Council Item 8.1 - Attachment 6 - Applicants response to submissions - 8-18 Oxford Street and 18 Mary Street Launceston

#### DA0497/2017 EAST LAUNCESTON PRIMARY SCHOOL

## East Launceston Primary School Further Clarifications

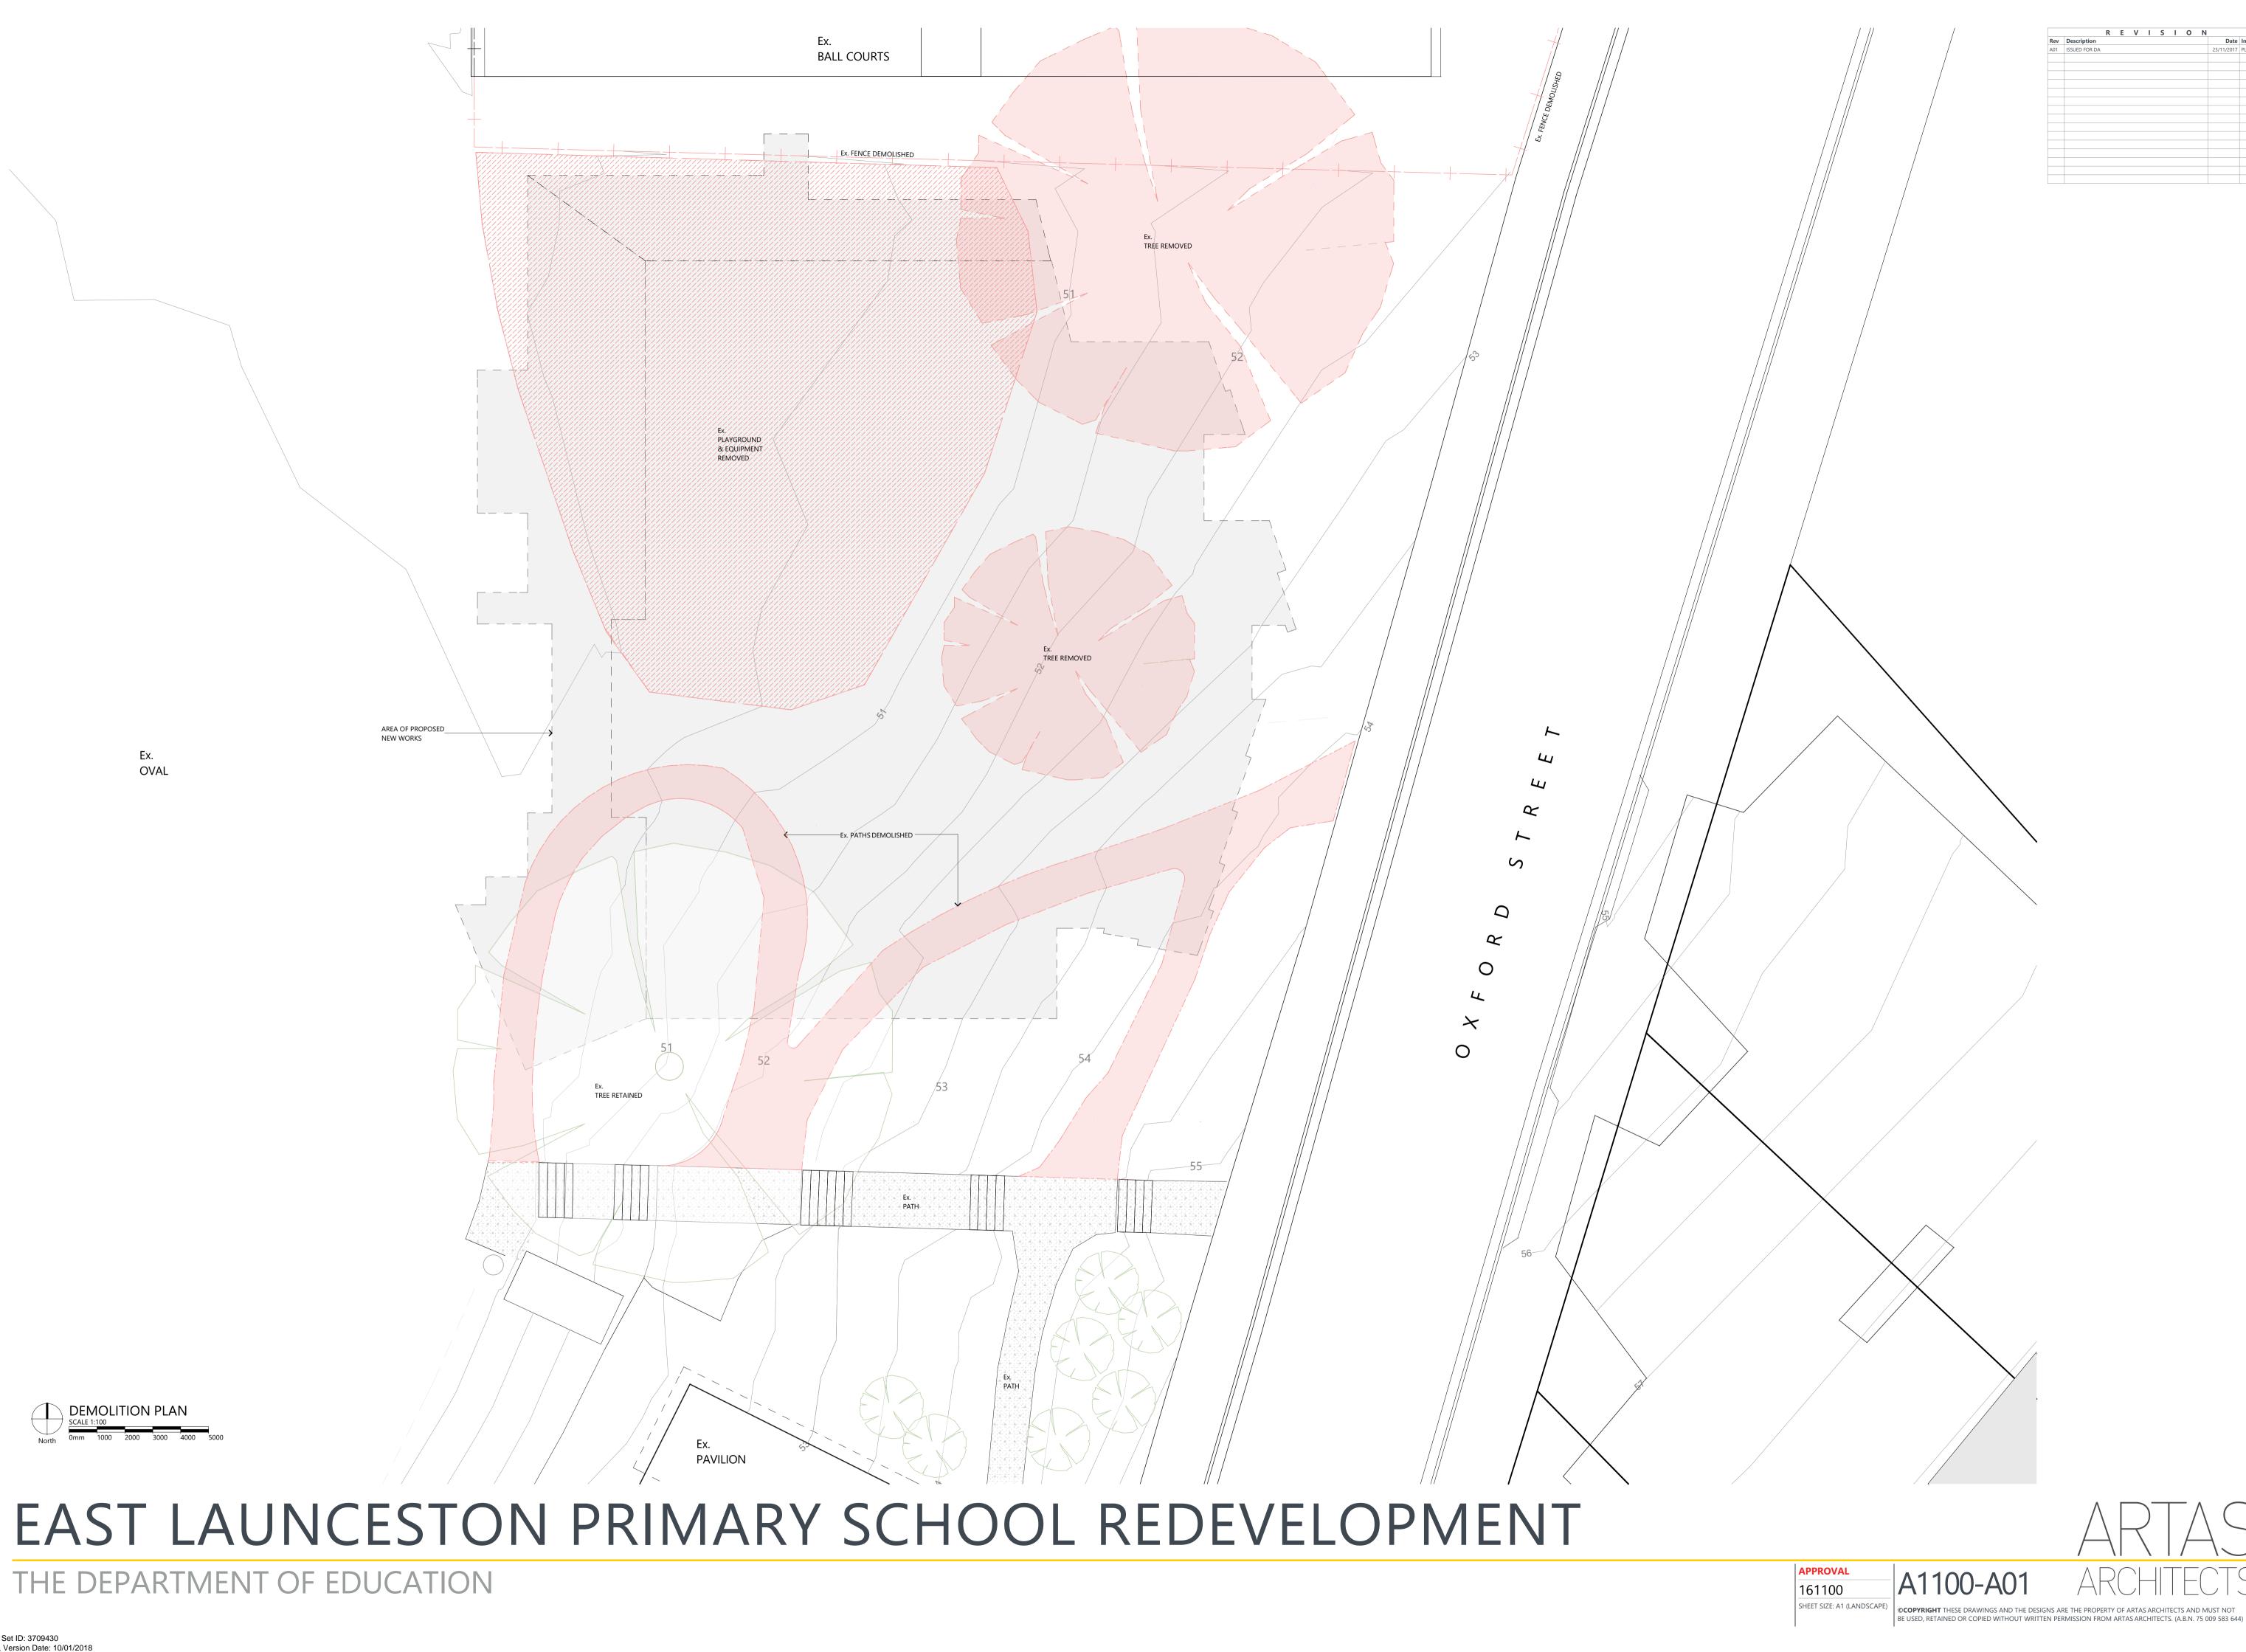
## 9. Which trees will be removed and retained if the kindergarten building were to be constructed? i.e. Oak tree, birch tree.

The proposed new kindergarten will result in two trees being removed. The existing oak tree will be retained. The attached demolition plan identifies the trees to be removed. Further details on the proposed landscape plan which will improve the area can be provided if required.
